Access Compliance Report Public Rights-of-Way (Curb Ramps)

Intersection ID: 21751Main Street:BRITTON_WOOD_PLCross Street:POPLAR_FOREST_DRLocation:SWADA ID: 012B6B34295ARamp Type:BlendTrans2Initial Pass/Fail:FailOverall Compliance:NoSeverity Score:10

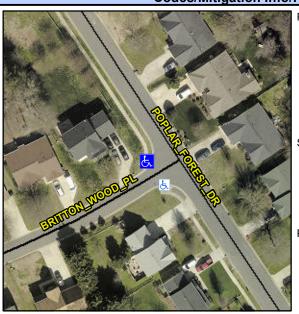
R304.5.1, R304.5.3

Compliance Description Data Compliance Description Data Yes N/A Ramp Length (in) 96.0 BlendTrans Slope (%) 3.0 No No Ramp Width (in) 39.0 BlendTrans XSlope (%) 4.0 N/A N/A Flare Type LT N/A Flare Type RT N/A N/A Flare Slope LT (%) N/A N/A Flare Slope RT (%) N/A N/A Flare Traversable LT? N/A N/A Flare Traversable RT? N/A N/A Landing Length (in) N/A N/A **DWS Provided?** N/A N/A Landing Width (in) N/A N/A **DWS Contrast?** N/A N/A N/A N/A Landing Slope (%) DWS Length (in) N/A N/A Landing X Slope (%) N/A N/A DWS Full Width? N/A N/A Landing Curb? (Y/N) N/A N/A DWS Offset (in) N/A N/A N/A Shared Landing? N/A **Gutter Ponding?** N/A N/A Gutter Slope (%) N/A N/A Gutter Lip Ht (in) N/A N/A Gutter X Slope (%) N/A N/A Painted X Walk1? No N/A Painted X Walk2? No X Walk 1 Direction To SE X Walk 2 Direction To NE N/A N/A X Walk 1 Width (in) X Walk 2 Width (in) X Walk 1 Slope (%) 2.4 X Walk 2 Slope (%) 4.7 X Walk 1 X Slope (%) 3.7 X Walk 2 X Slope (%) 3.2 N/A N/A Ramp inside XWalk2? N/A N/A Ramp inside XWalk1? Road Slope (%) 3.0 Clear Space? N/A N/A Road X Slope (%) Clear Space to XWalk (in) N/A 4.4 N/A N/A N/A Any Obstructions? Storm Grate/Utility Hazard? N/A **Obstruction Type** Storm Grate/Utility Type N/A N/A Yes Surface Condition? (G/P) Good

Remove & Replace Curb Ramp With Two New Directional Ramps or Equivalent.
